# Groundwater Application Review Summary Form

Application # G- 19023

GW Reviewer Jen Woody Date Review Completed: 03/24/2023

TO: Water Rights Section Date 03/24/2023  
 FROM: Groundwater Section Jen Woody  
 Reviewer's Name  
 SUBJECT: Application G- 19023 Supersedes review of 7/23/2021  
 Date of Review(s)

Figure 3. Water-Level Measurements in Nearby Wells

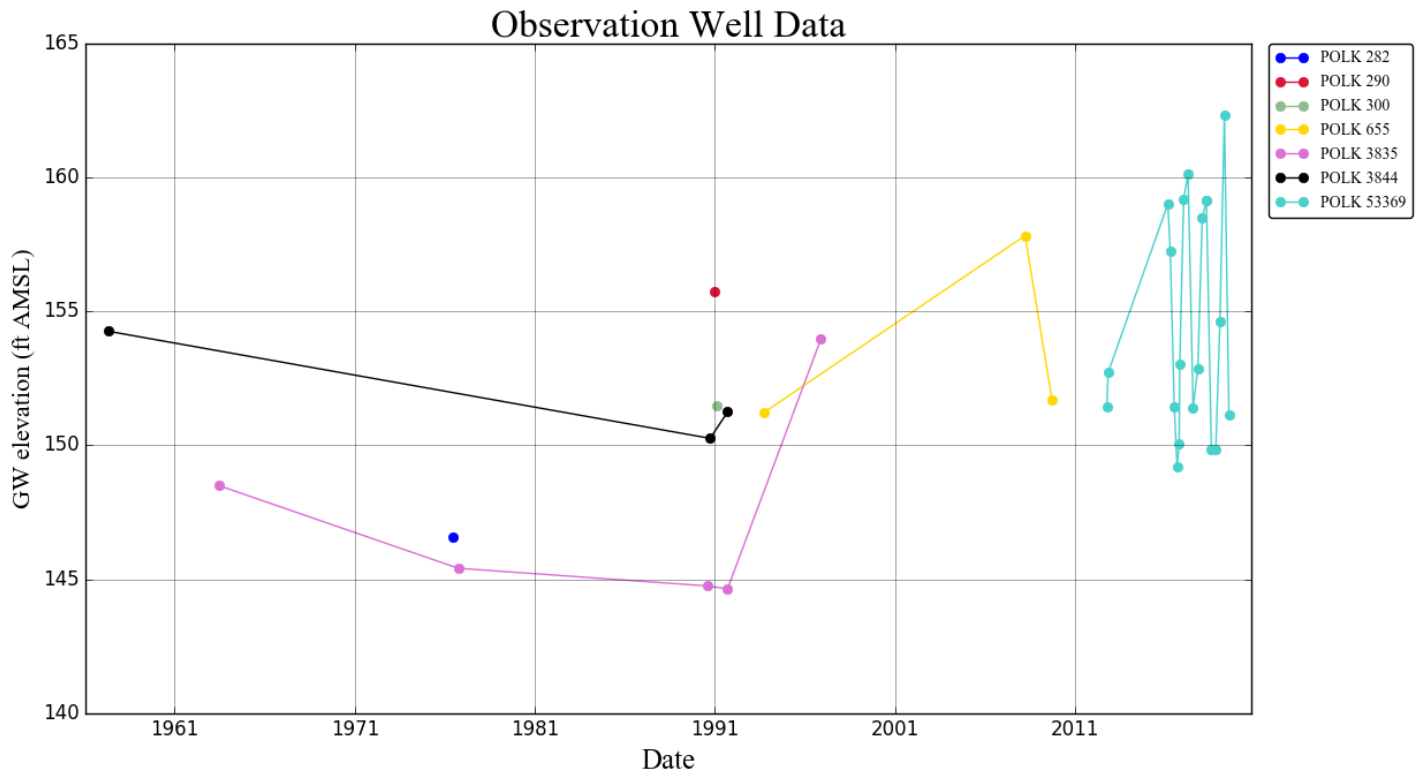
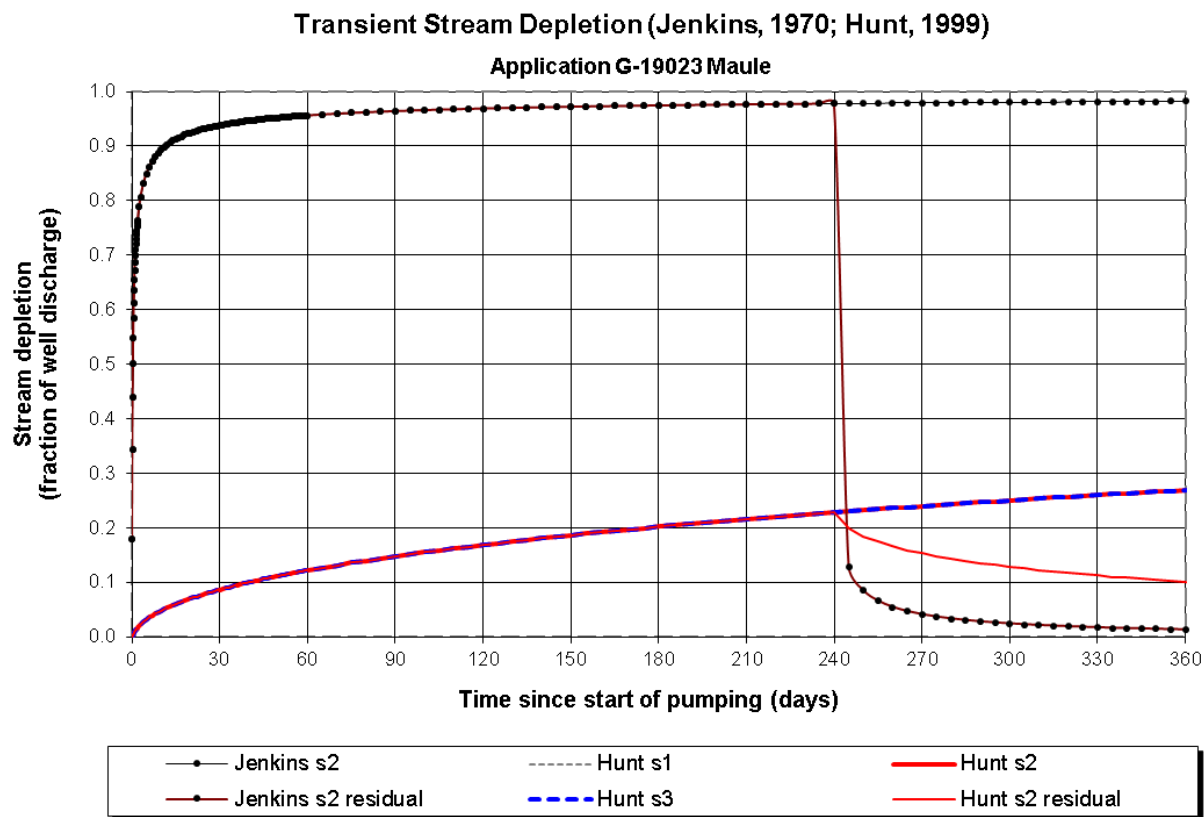
Nearby water level data are sparse, but show general stability at the current level of use.

Section B1a of this review was updated according to the Iverson (2023) memo. The water level data from nearby wells represents the same groundwater sources as the proposed use, represents current hydrologic conditions and established a

sufficient interannual water level trend that does not meet the Division 8 definition of excessively declining or declined excessively (OAR 690-008-0001(4)(d)). Therefore the reviewer finds B1a “ is not over appropriated”.

Figure 4. Stream Depletion for the well closest to surface water; most conservative stream depletion estimate is less than 25% at 30 days.

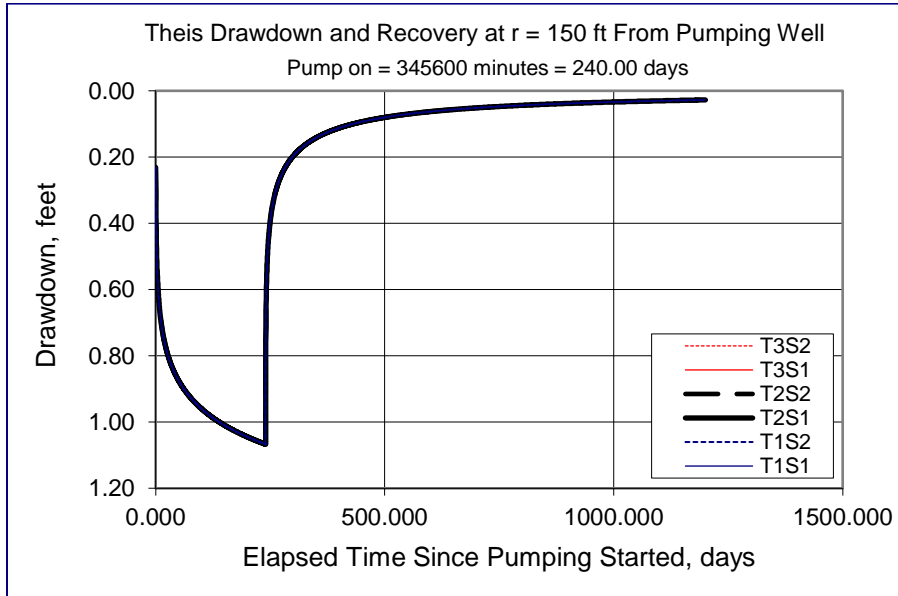
C3a. **690-09-040 (4):** Evaluation of stream impacts for each well that has been determined or assumed to be **hydraulically connected and less than 1 mile** from a surface water (SW) source. Limit evaluation to instream rights and minimum stream flows that are pertinent to that SW source, not lower SW sources to which the stream under evaluation is tributary. Compare the requested rate against the 1% of 80% *natural* flow for the pertinent Water Availability Basin (WAB). If Q is not distributed by well, use full rate for each well. Any checked  box indicates the well is assumed to have the potential to cause PSI.

Well	SW #	Well < ¼ mile?	Qw > 5 cfs?	Instream Water Right ID	Instream Water Right Q (cfs)	Qw > 1% ISWR?	80% Natural Flow (cfs)	Qw > 1% of 80% Natural Flow?	Interference @ 30 days (%)	Potential for Subst. Interfer. Assumed?
1	1	<input checked="" type="checkbox"/>	<input type="checkbox"/>	n/a	n/a	<input type="checkbox"/>	3620	<input type="checkbox"/>	<25%	<input checked="" type="checkbox"/>
